Bid 622
**Rancho Campana High School HVAC Modernization Project for Oxnard
Union High School District**

ADDENDUM #2

Dated: June 12th, 2020

BUILDINGS A & C1
MECHANICAL ROOF PLAN

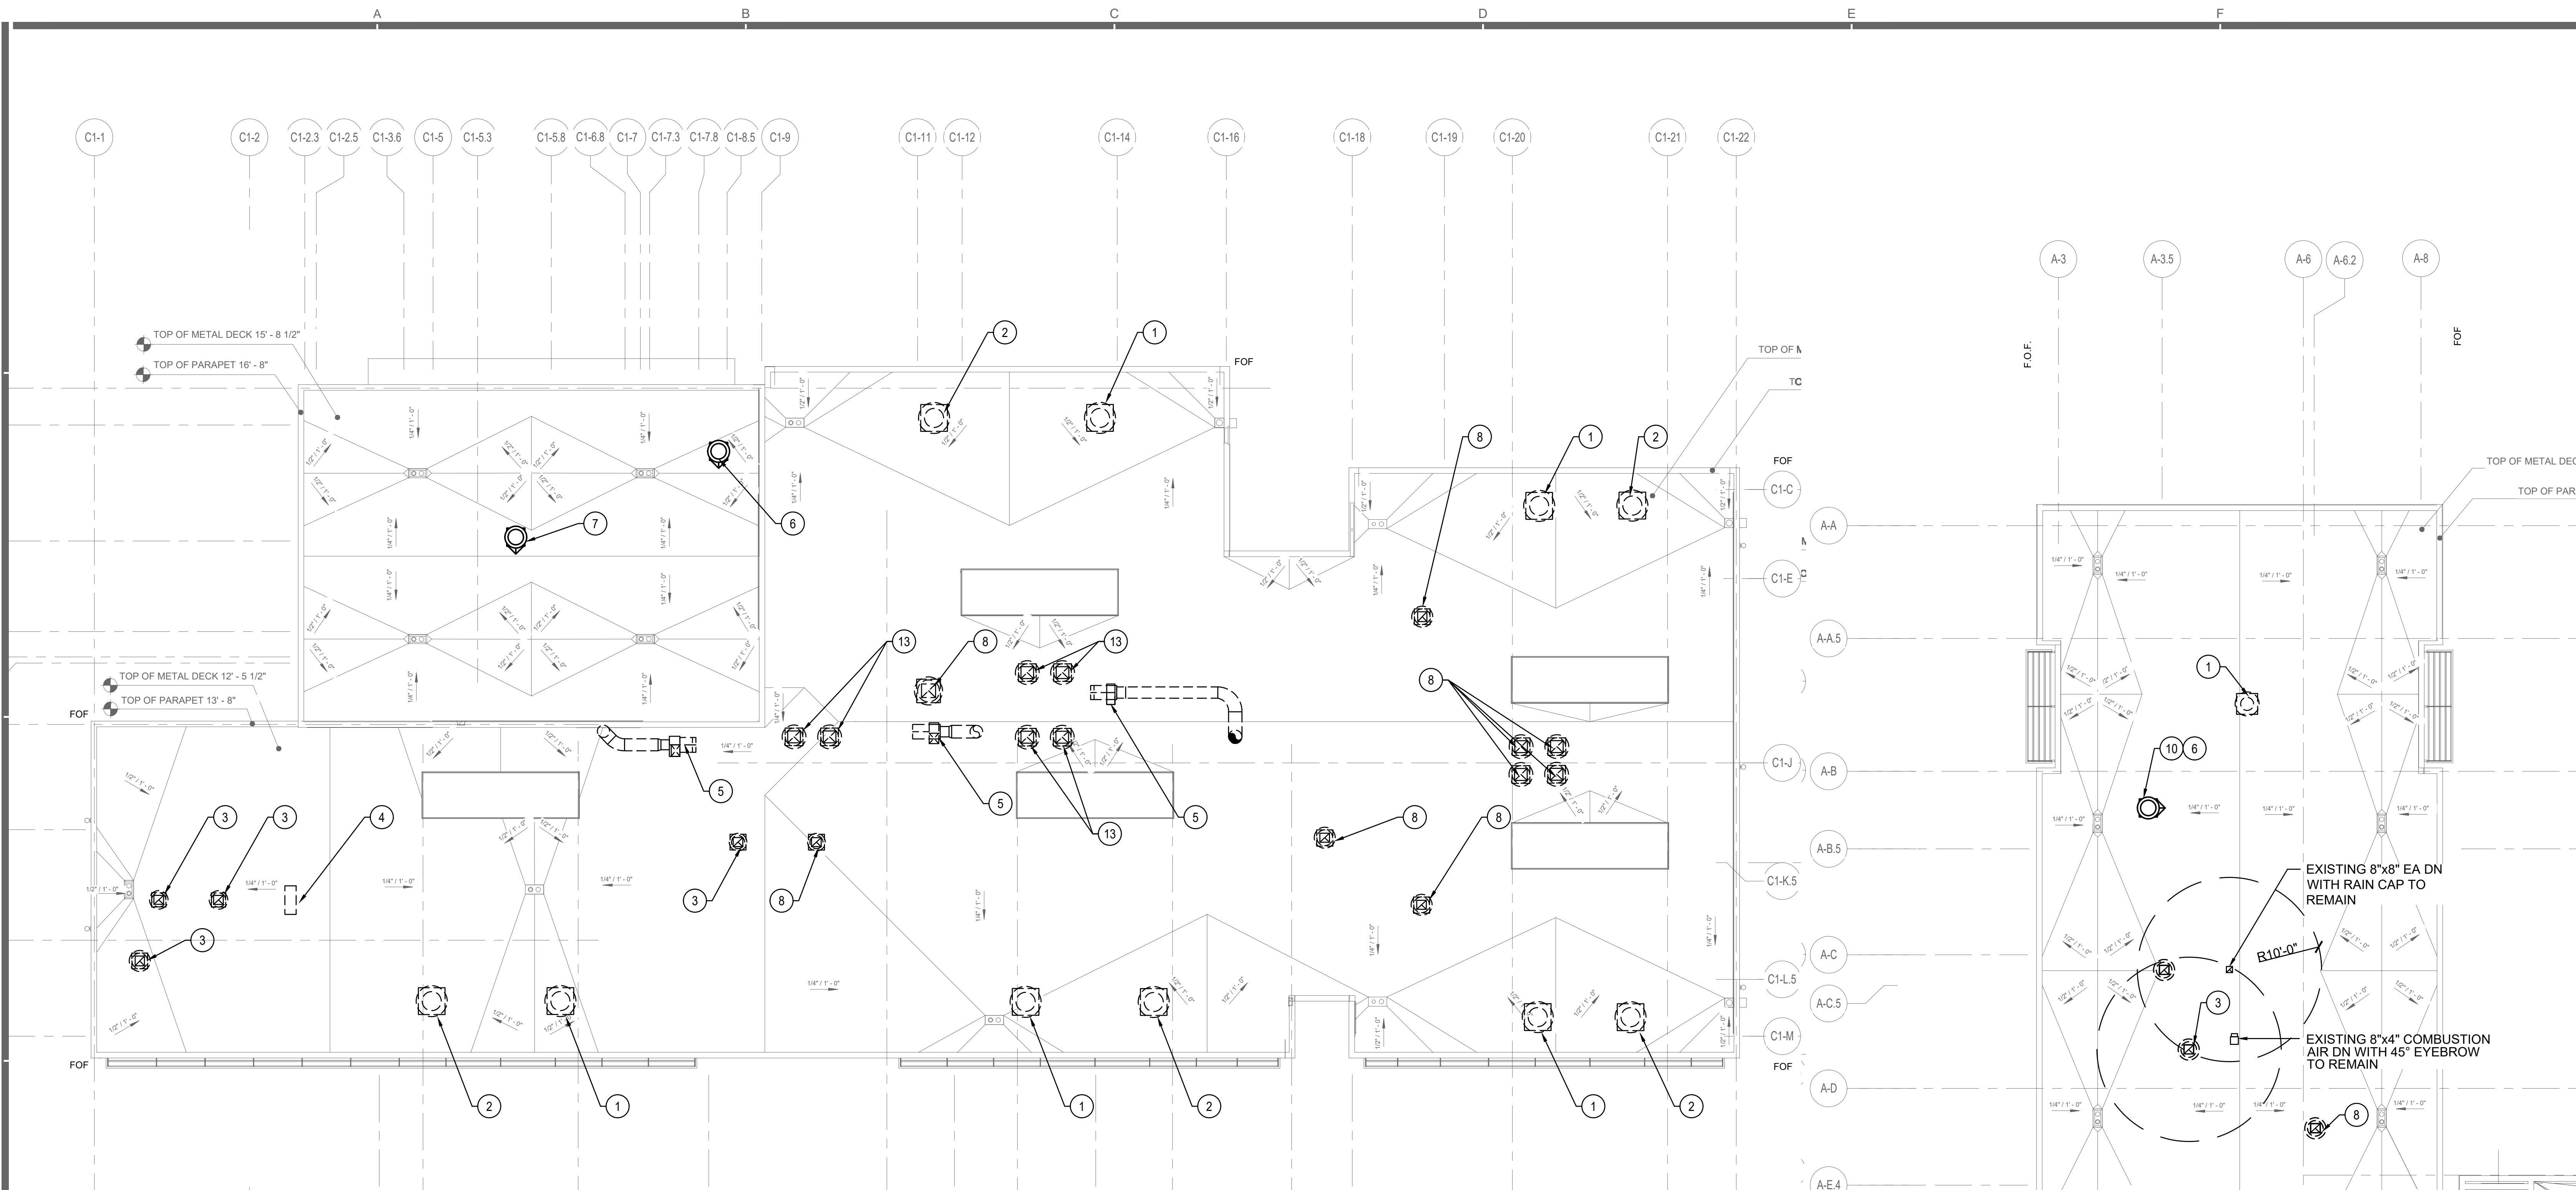
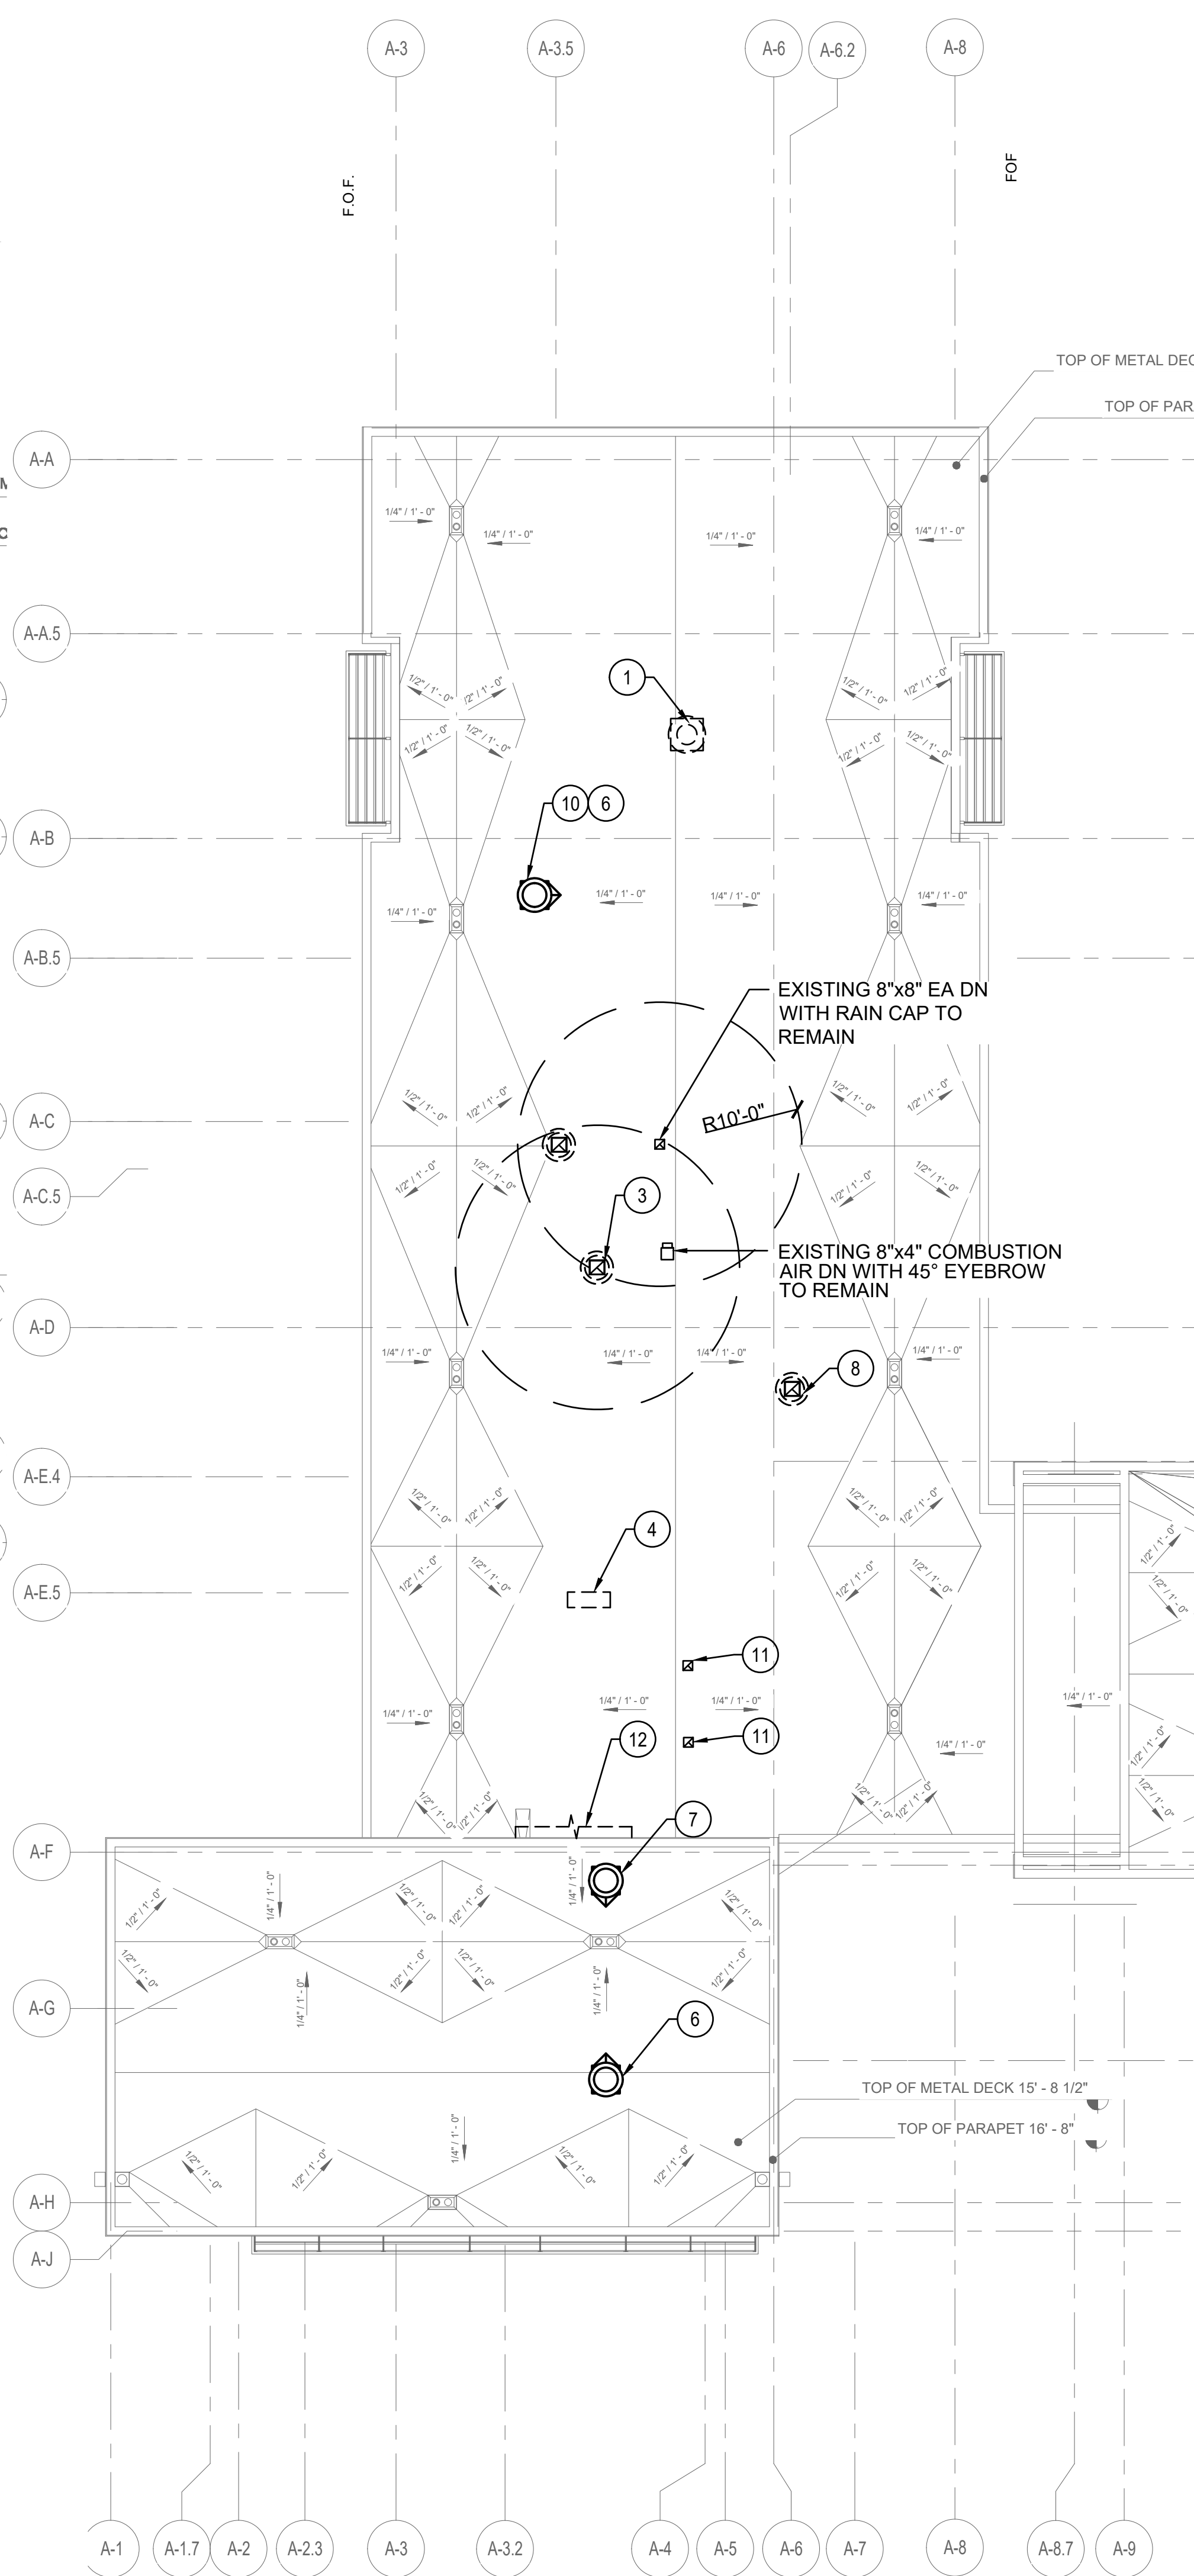
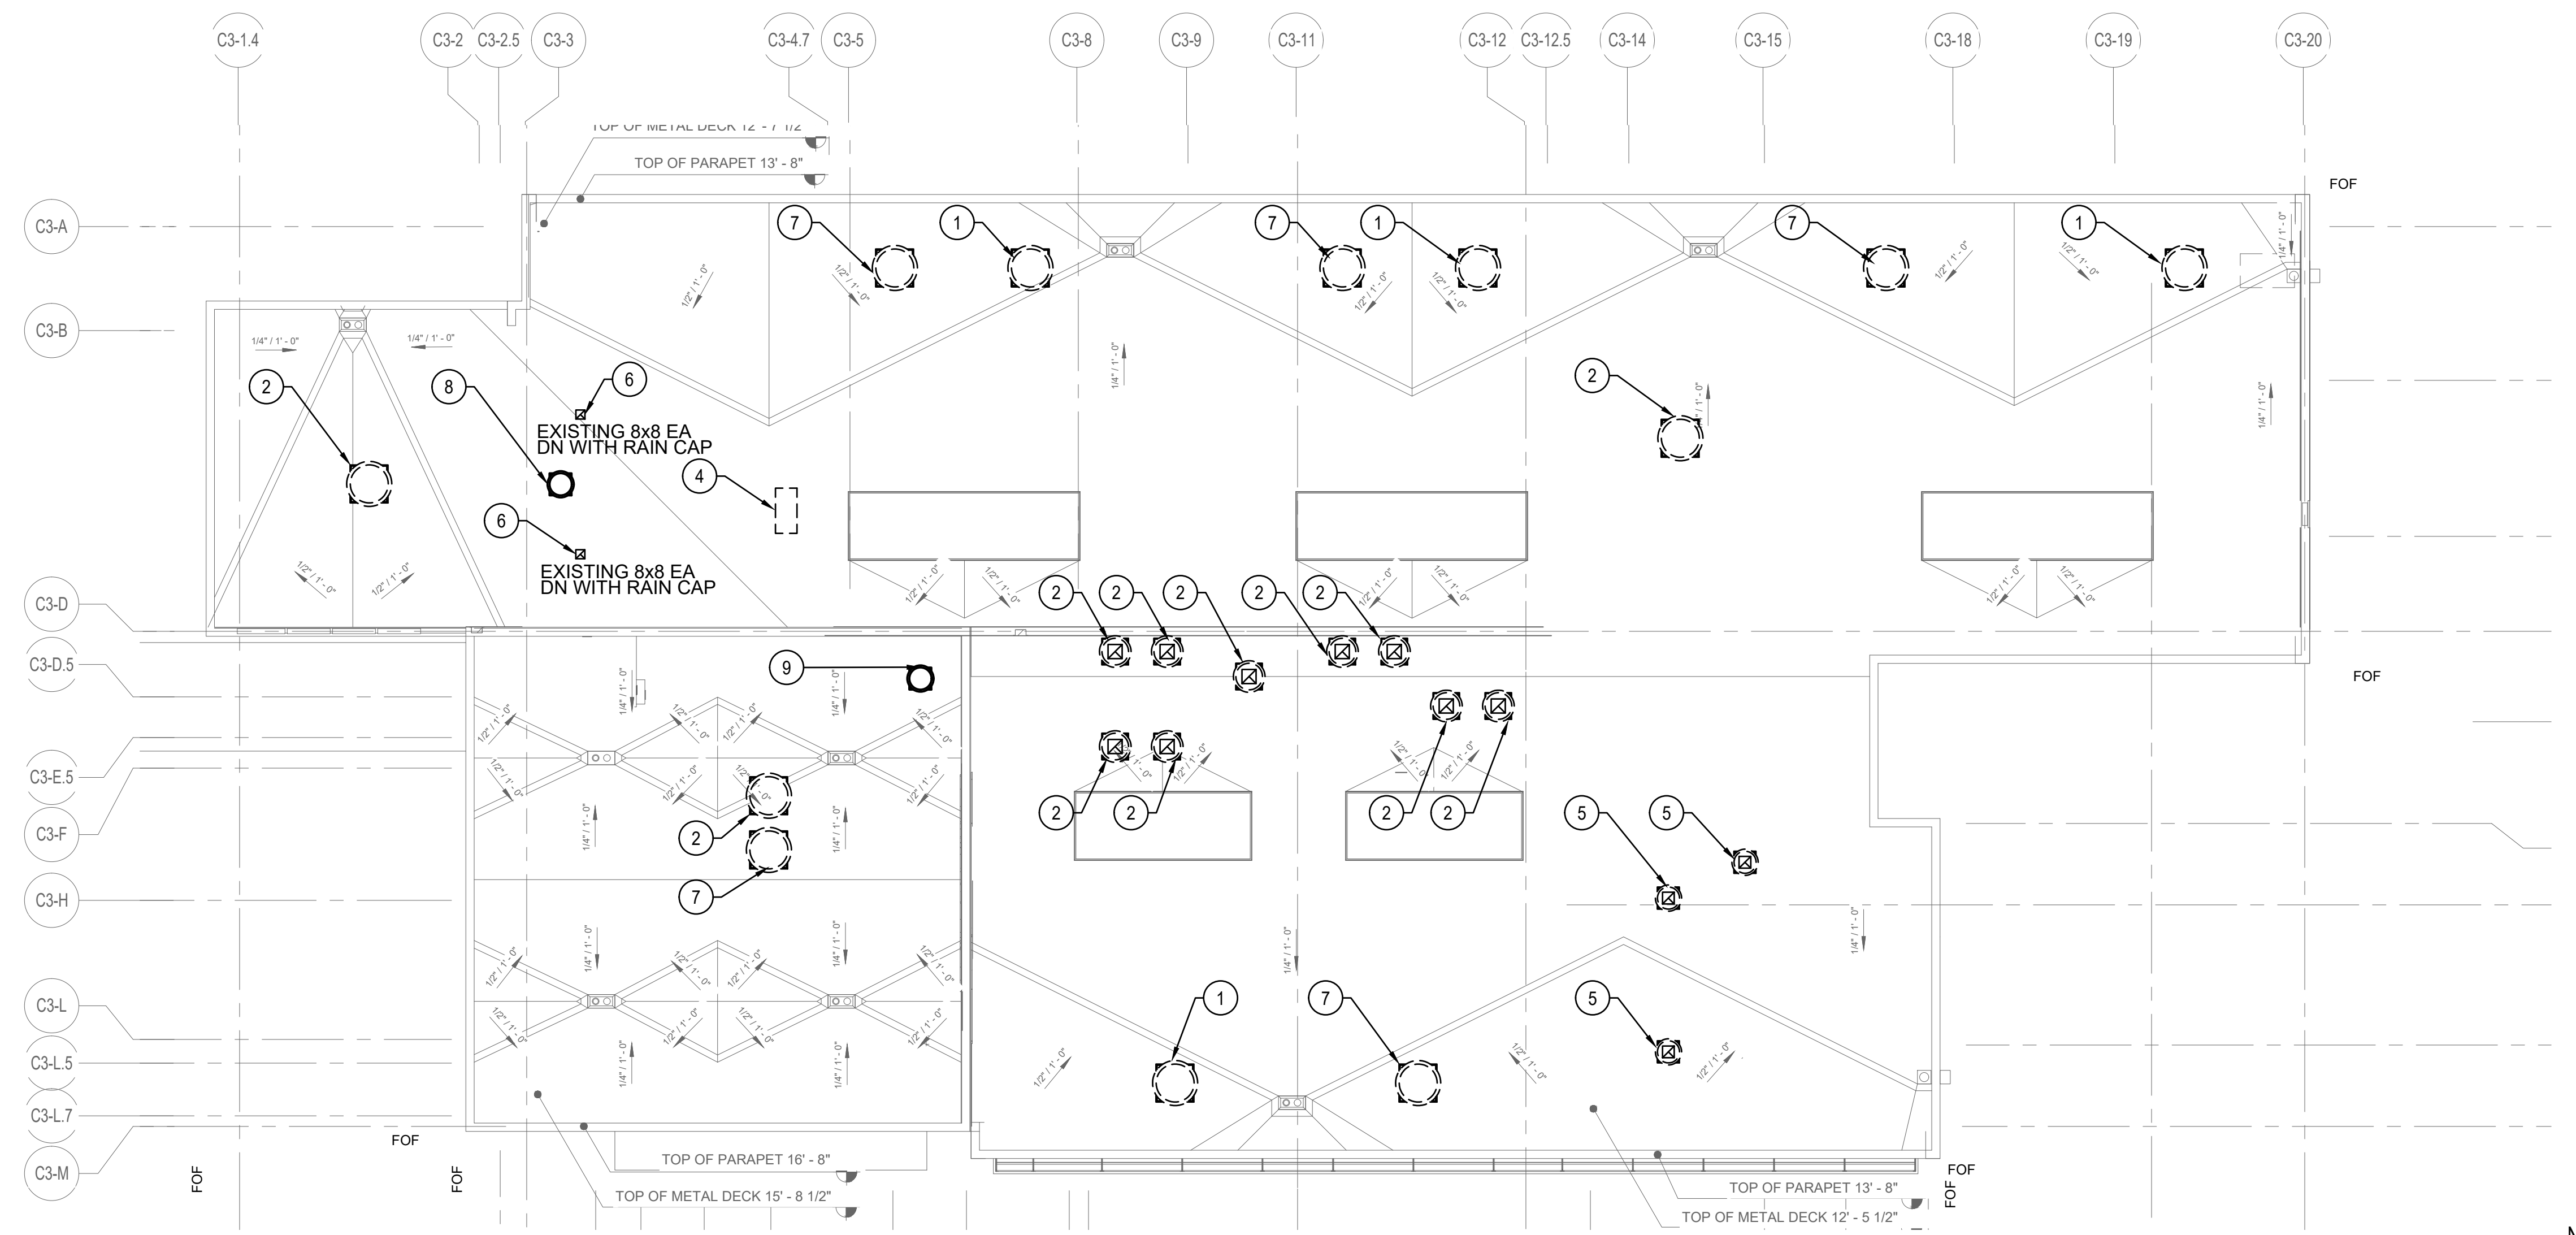
- 7. M2.01 Demo detail note M – remove OSA Damper – will this require any re-fabrication to support new relief damper?
- 8. What is required on roof top for new gravity vents to be installed by Mech.

7. M2.01 Demo detail note M – remove OSA Damper – will this require any re-fabrication to support new relief damper? B&A Response: Yes.
8. What is required on roof top for new gravity vents to be installed by Mech.
 B&A Response: See Addendum and detail 3/M7.05. See Architectural for roof patching and flashing. (See attachment I)

9. What is required on roof top for new Exhaust Fans to be installed by Mech?
 B&A Response: No new exhaust fans are being installed.
10. What is required on roof top for new OSA to be installed by Mech?
 B&A Response: See Addendum and detail 3/M7.05. See Architectural for roof patching and flashing. (See attachment I)
